2009 Corvette Z06 and ZR1: GM TechLink Article: Oil System Changes - LS7 and LS9

Changes have been made to the dry-sump engine oil system used in the 2009 Corvette

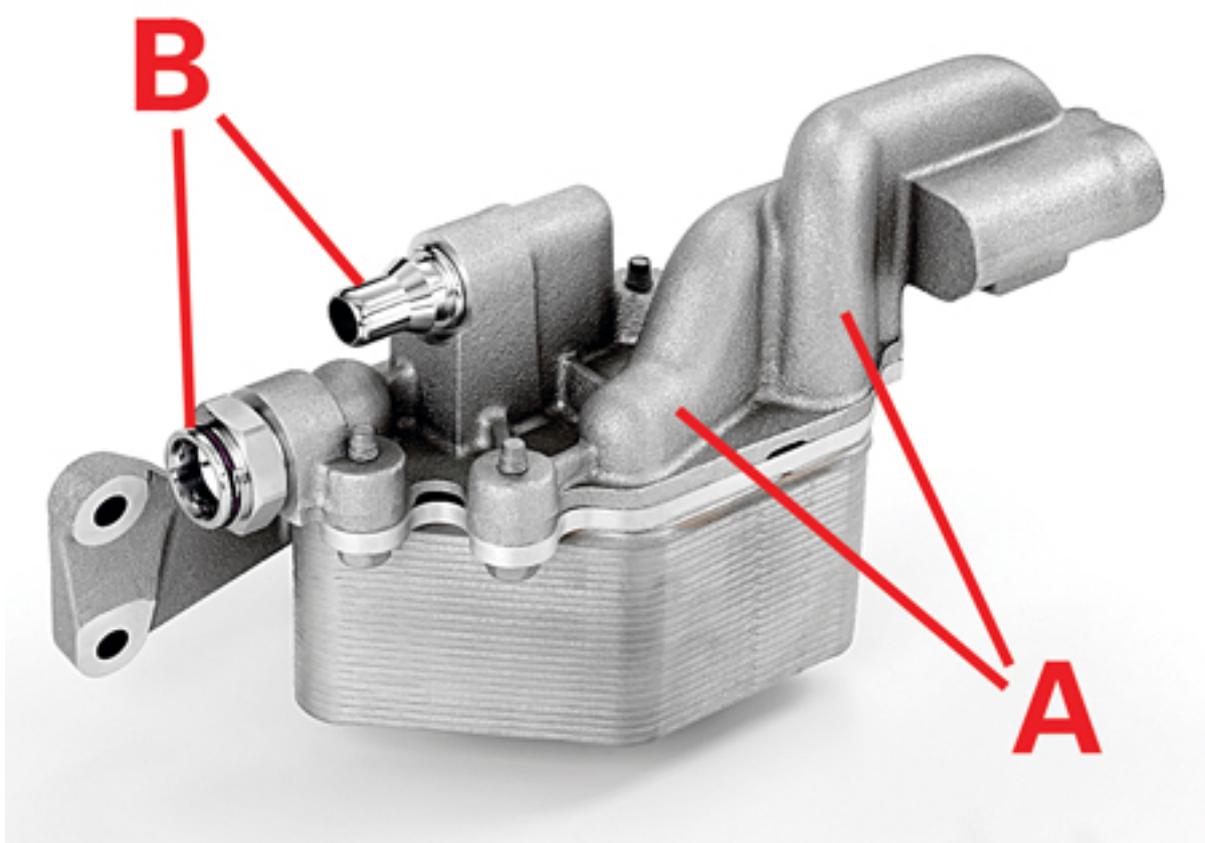
The dry sump system uses a dual gerotor oil pump, one rotor for scavenge and one rotor for supply (fig. 2) . The pump used on the LS9 produces greater volume and higher system oil pressure to provide adequate oil delivery under all conditions.

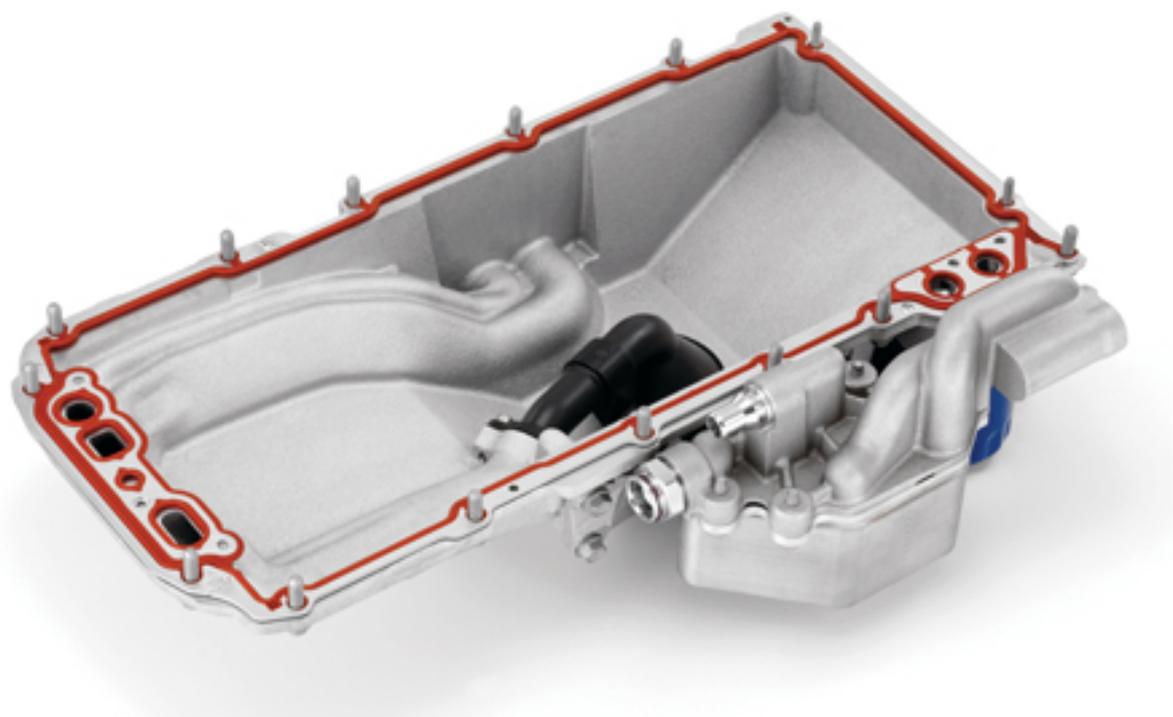
The LS9 uses eight oil squirters, one per cylinder, for additional lubrication of the pistons and cylinder walls (fig. 3) .

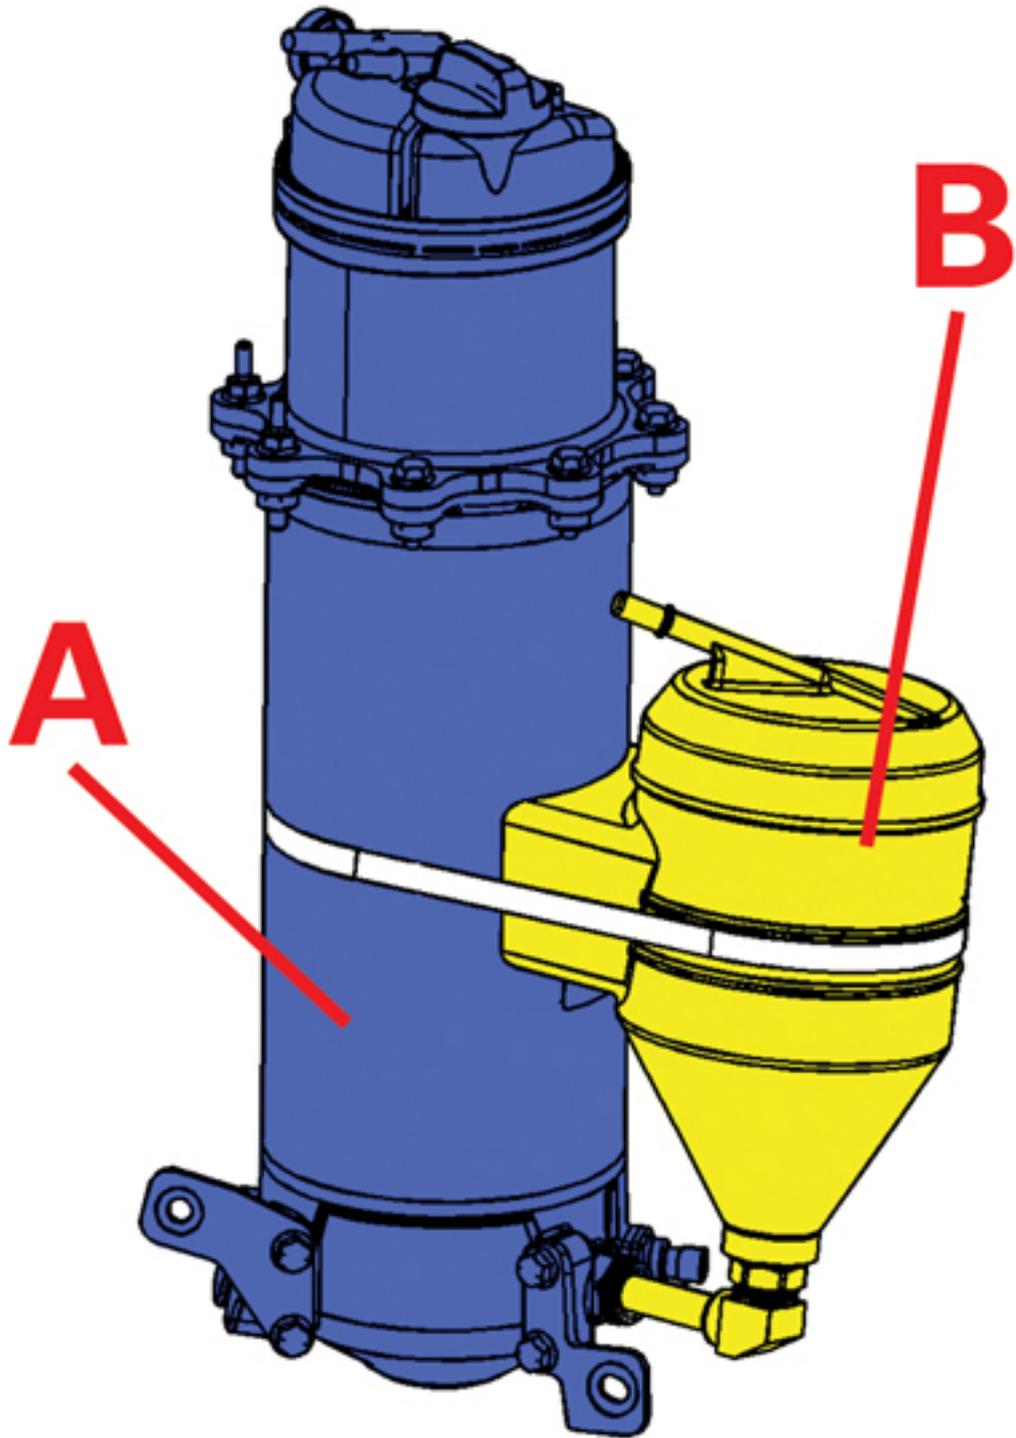
For both engines, the oil reservoir has been redesigned to increase the oil capacity of the system. Under extreme cornering loads such as experienced on a banked race track, extra oil capacity ensures that there is sufficient oil in the reservoir to avoid the ingesting of air due to slosh. A second tank is connected to the main tank by tubing (fig. 6) .
